Draft – Qualitative Assessment Framework

1 Introduction

Figure 1 - RIS Decision Tree Flowchart

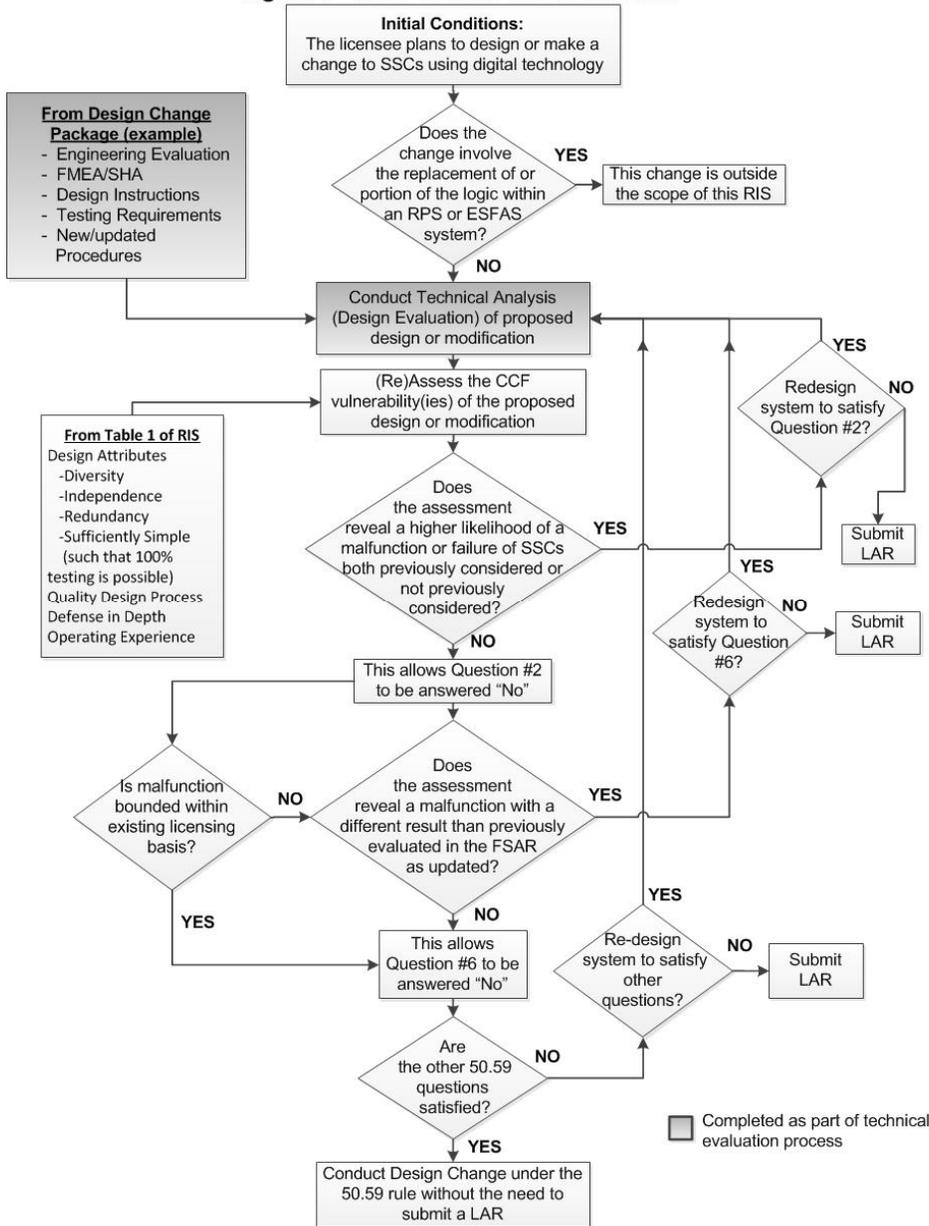
Commented [vxf26]: There is no box for 50.59 Question #6.

Commented [vxf27]: Many of the "rectangles" on the flow chart do not have a "yes" or "no". For instance, the box that contains "This allows Question #2 to be answered NO". Please clarify this in the flowchart.

Commented [vxf28]: Please refer to previous comment on the 100% testability in Table 1.

Commented [vxf29]: Please clarify what the purpose of the decision block that states: "Is malfunction bounded within the existing licensing basis?"
